**DOCUMENT 00 90 00
ADDENDUM**

ADDENDUM NO. [1] Date: February 17, 2020

**RE: WESTERN TECHNICAL COLLEGE
 APPRENTICESHIP CENTER REMODEL
 2860 21ST PLACE SOUTH
 LA CROSSE, WISCONSIN 54601
 HSR PROJECT NO. 19021**

This Addendum consists of [2] page, [1] specification sections and [9] 30 x 42 drawings.

GENERAL NOTES:

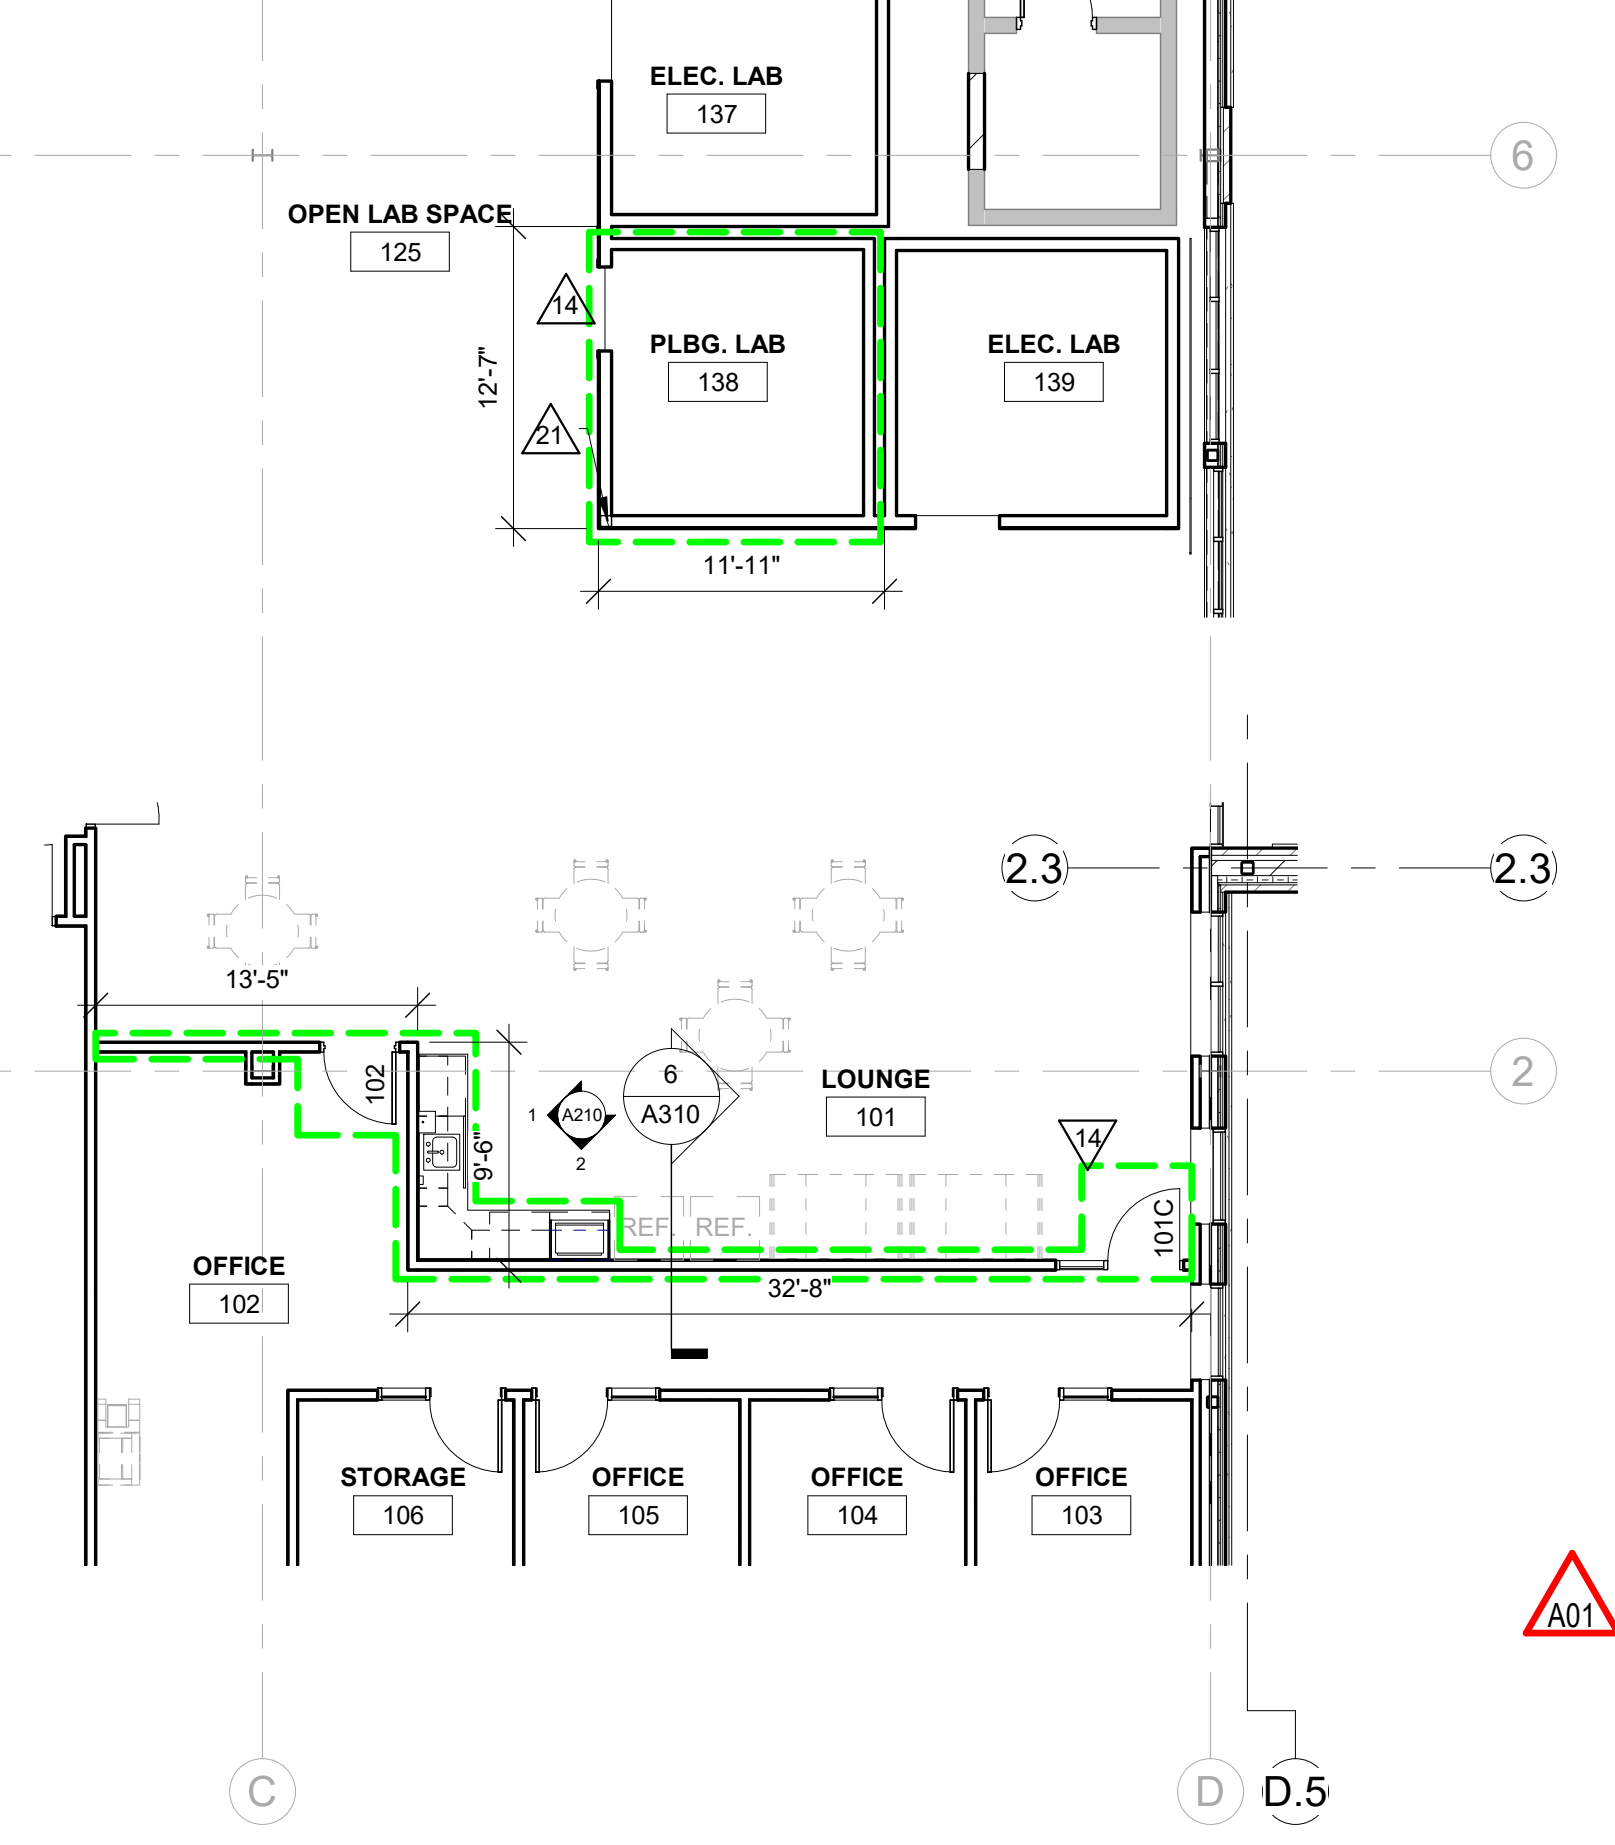
4. Sheet C200 LAYOUT PLAN 30 x 42 attached hereto
 - a. Revisions clouded on Drawing.
5. Sheet A100 FIRST FLOOR REMODEL PLAN 30 x 42 attached hereto
 - a. Revisions clouded on Drawing.

1 ROOF PLAN
1/8" = 1'-0"

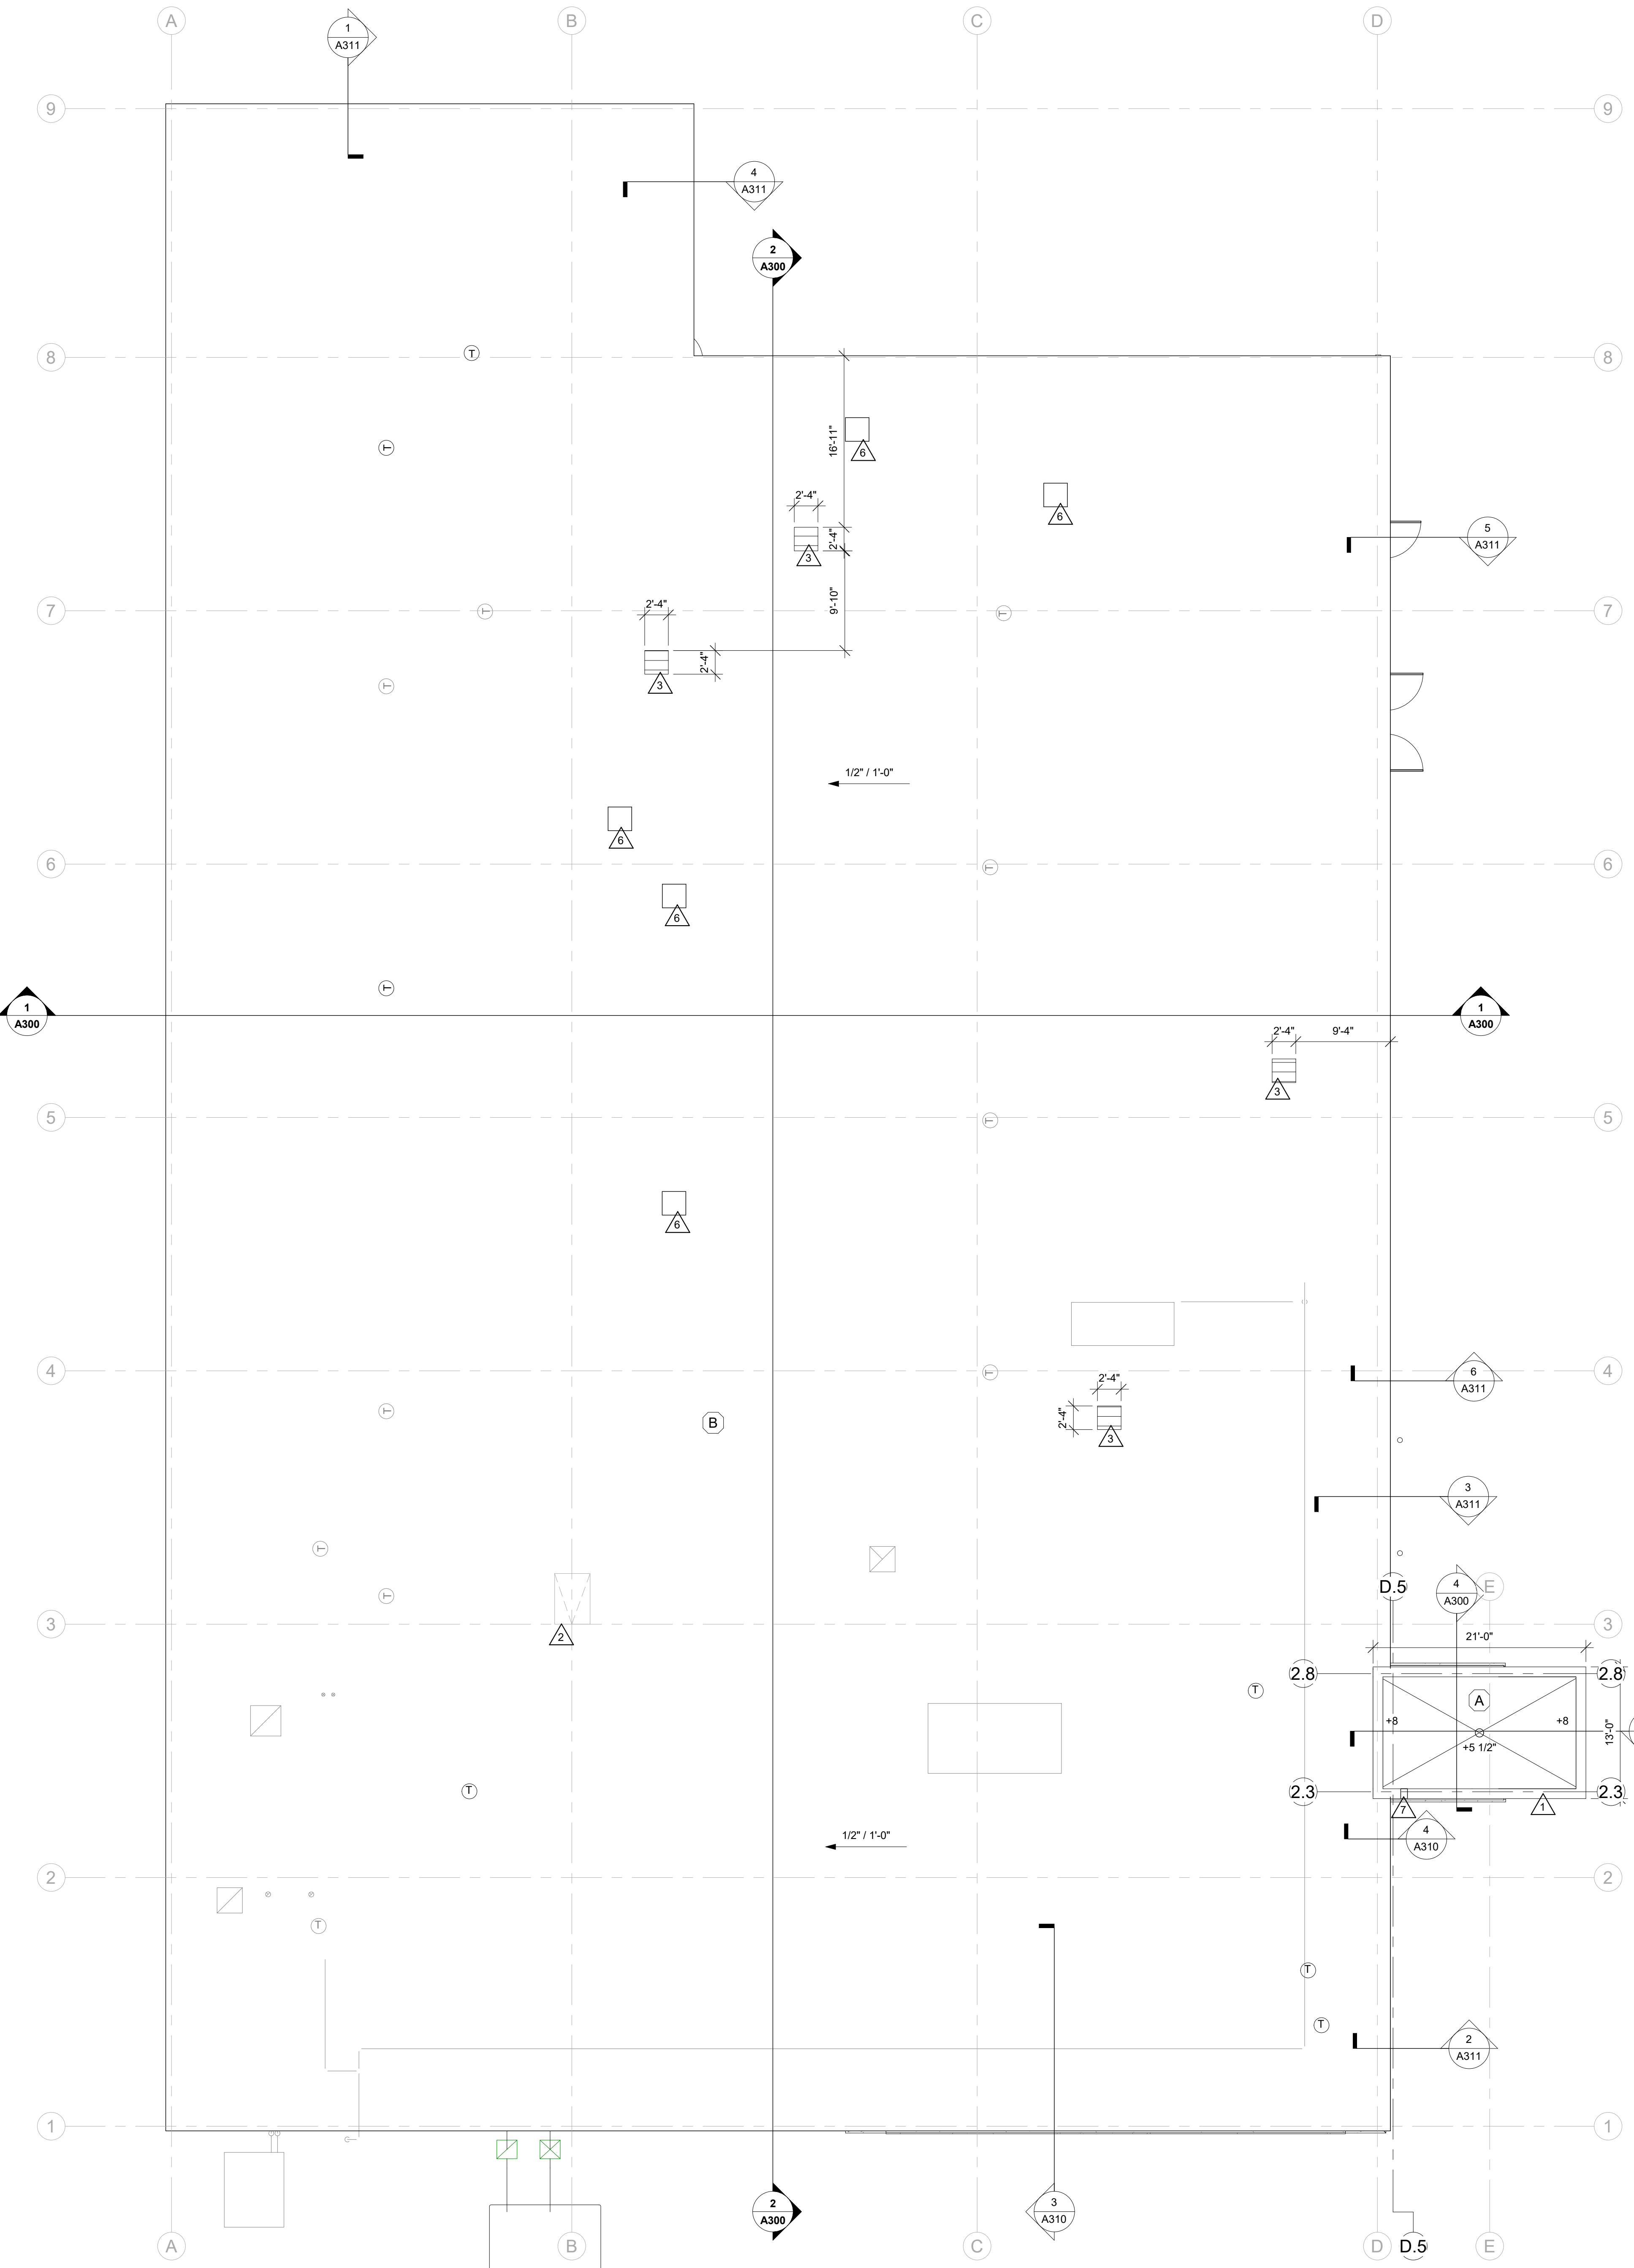
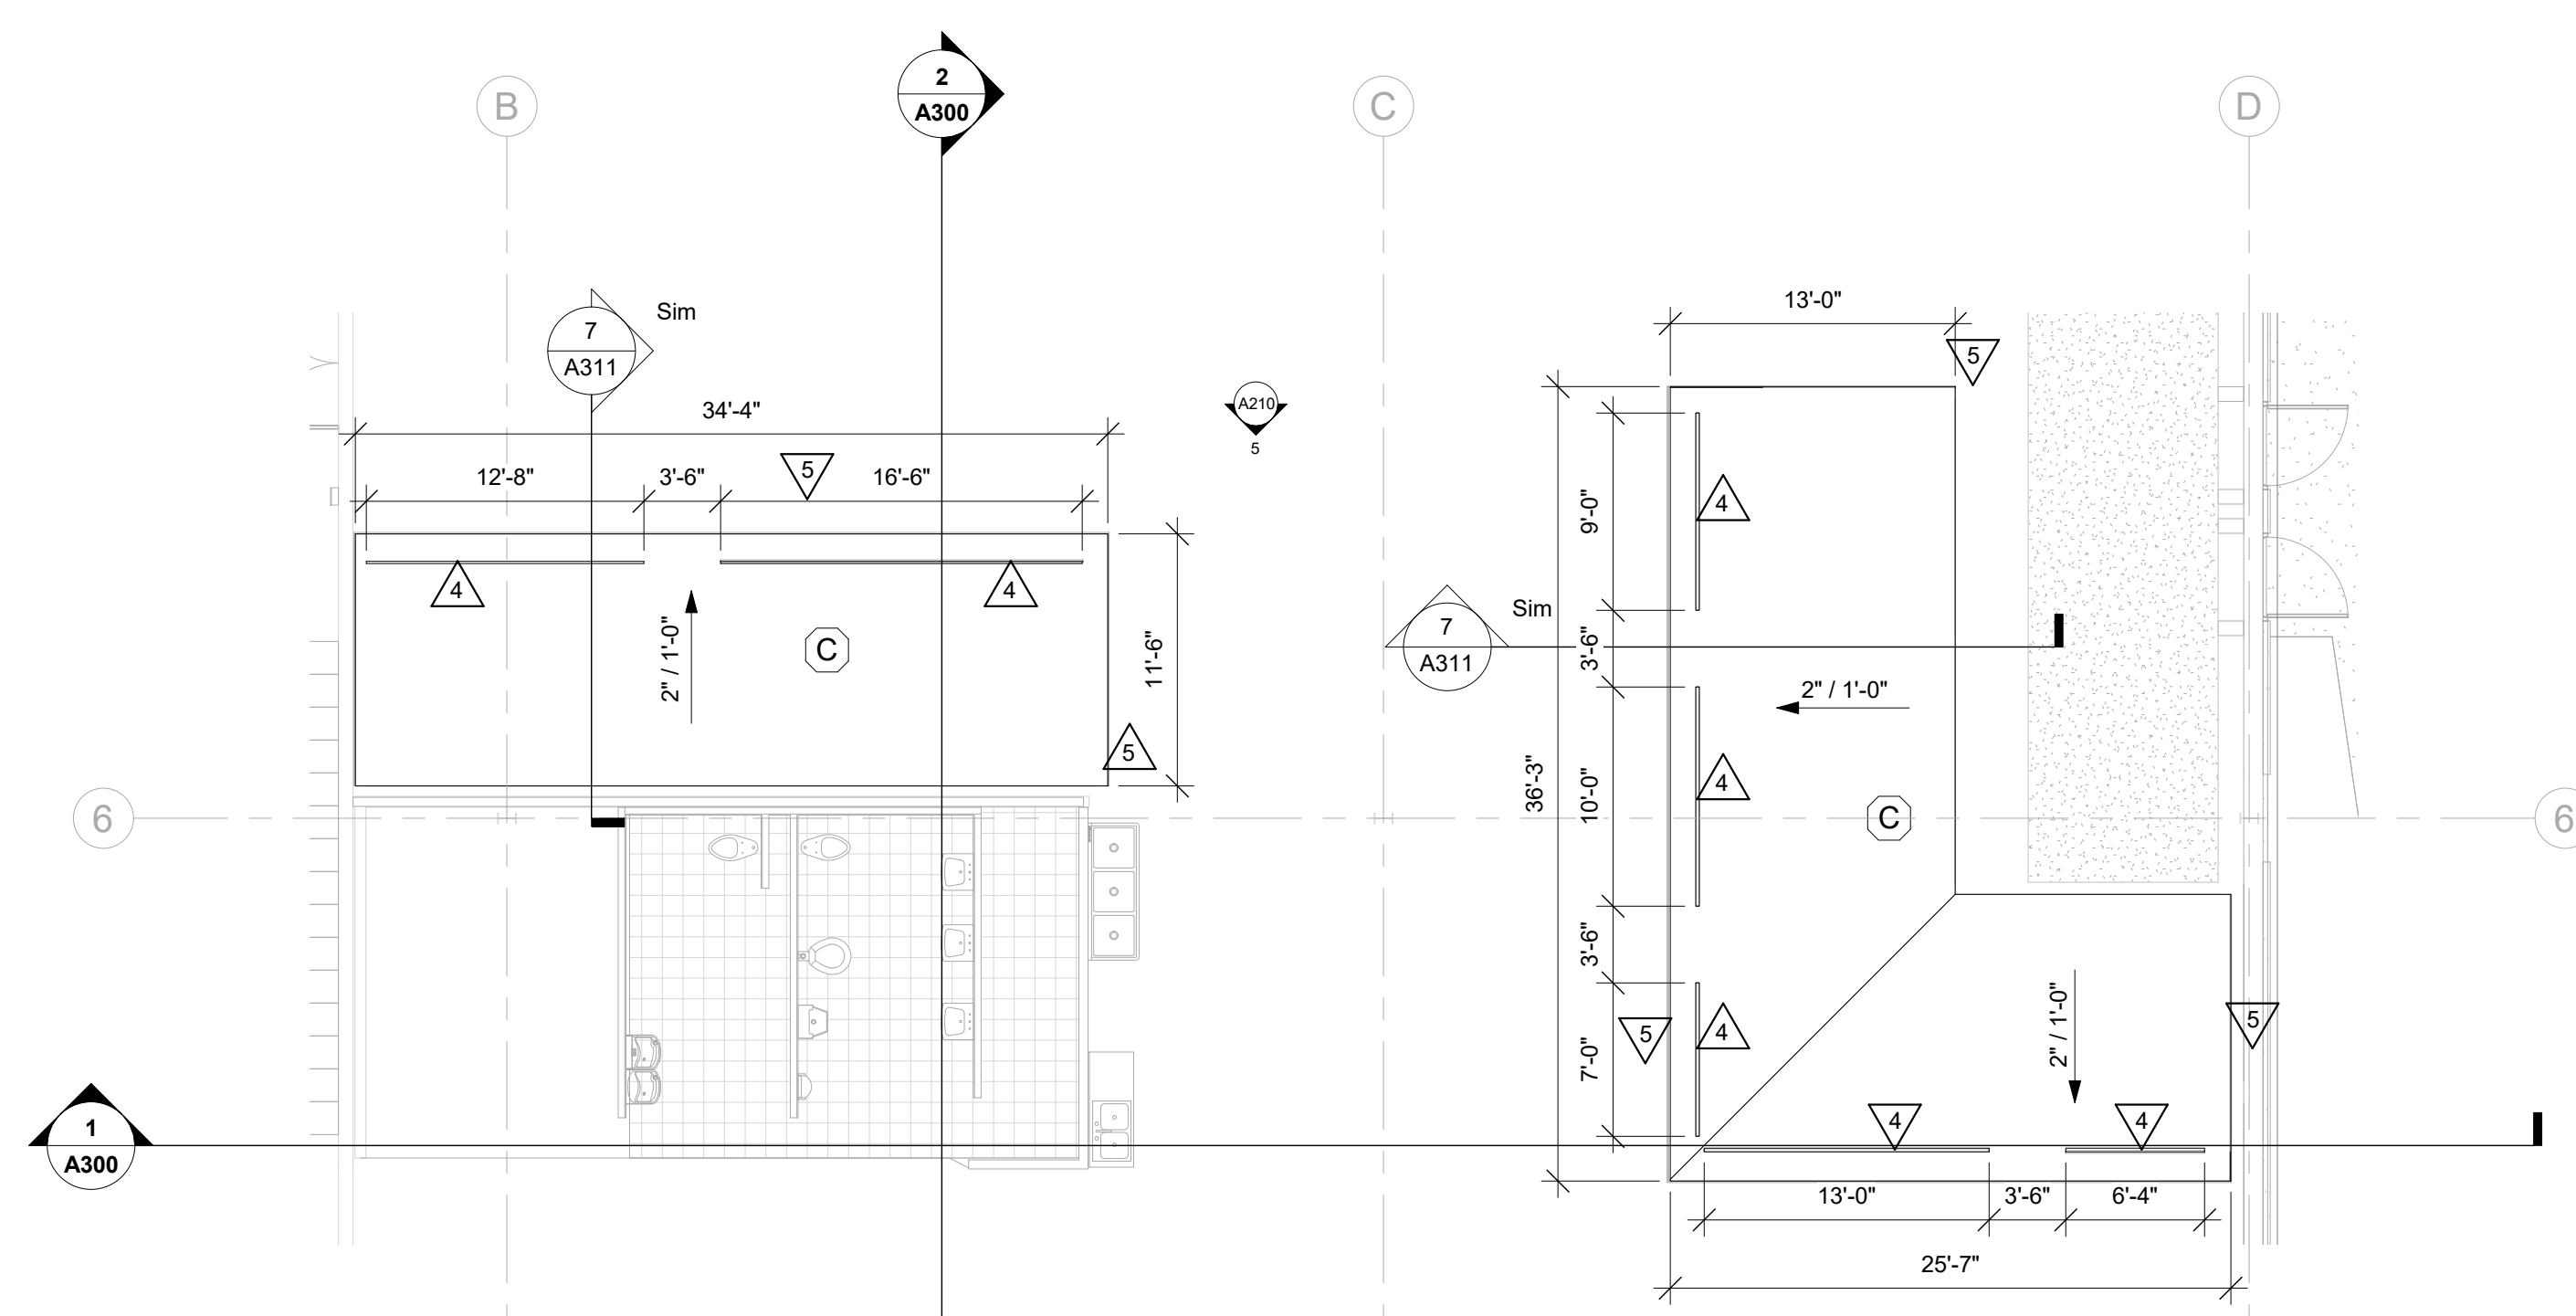
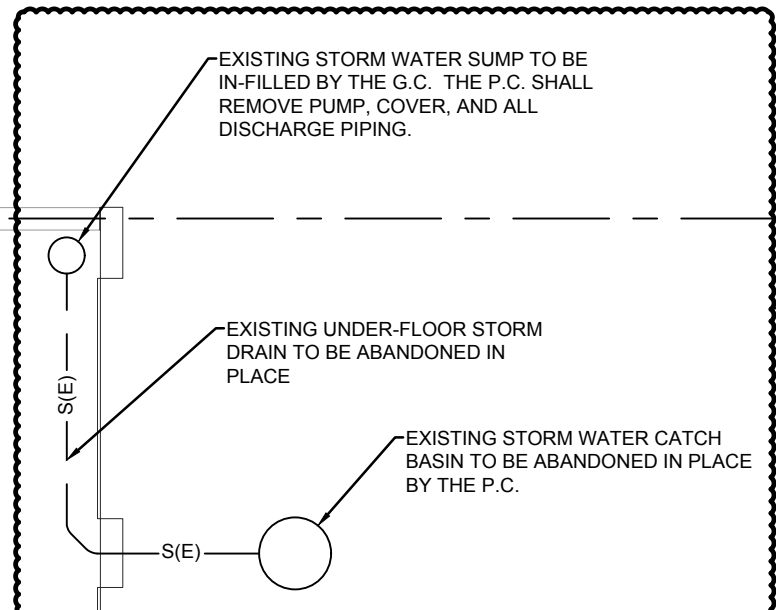
6. Sheet A120 ROOF 30 x 42 attached hereto
 - a. Revisions clouded on Drawing.
7. Sheet P090 PLUMBING UNDERFLOOR DEMOLITION PLAN 30 x 42 attached hereto.
